MEETING MINUTES

Subject: North Slope & Sodium Dichromate Sampling Plan Comments

COMMENT DISPOSITION FOR ECOLOGY COMMENTS
NORTH SLOPE ERA PROJECT PLAN/SAMPLING PLAN

Comment Disposition for the Sodium Dichromate Project Plan

Figure 1-1. Site Grid

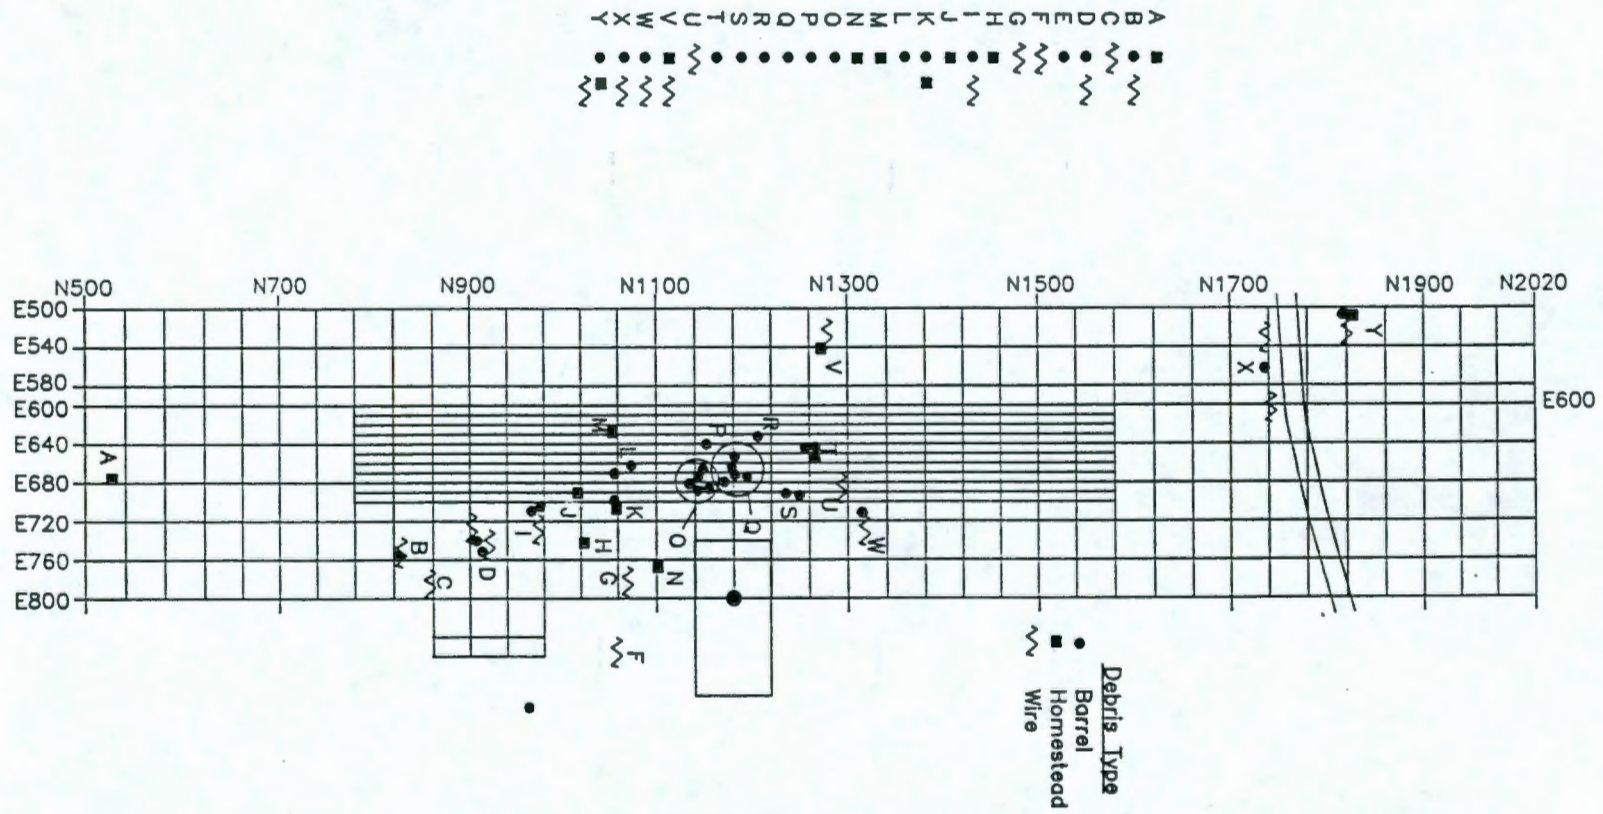
This part of the document must be rewritten to describe actual methods of sampling, schedule, and details on sampling procedures/protocol. Location of each site must be identified with maps. Criteria for when a sample will be taken and the minimum number of samples must be provided. The description must also include the actual methods of sampling, decontamination procedures, and methods of handling the waste generated during this sampling event. Field screening of volatiles using UVA must be used at the site.

Soil sample collection will include nonintrusive surface sampling and two test trenches. Ground-penetrating radar (GPR) and electromagnetic induction (EMI) surveys per II 11.2 Geophysical Survey Work (WHC 1988b), and a visual inspection for surface debris will be completed to identify sample locations. Sampling will be done to support the ERA Proposal document. Sample locations are shown in Table 1-1 and Figure 1-1. Field samples will be screened with an Organic Volatile Analyzer.

Nonintrusive surface sampling depth limits for collecting soil samples is 1 ft or less. Sample locations are shown on Table 1-1 and Figure 1-1. Additional sample locations maybe determined by the field team leader.

Test trenches will allow access for soil sampling and characterization at depths greater than 1 ft. GPR and EMI survey results indicate 3 large anomalies (Figure 1-1). Two test trenches will be dug by backhoe. Each trench will be about 50 ft. long, up to 20 ft deep, and with enough lateral extent to safely achieve the required depth. The trenches will be constructed and backfilled in compliance with EII 5.2, Soil and Sediment Sampling, Appendix F, (WHC 1988b).
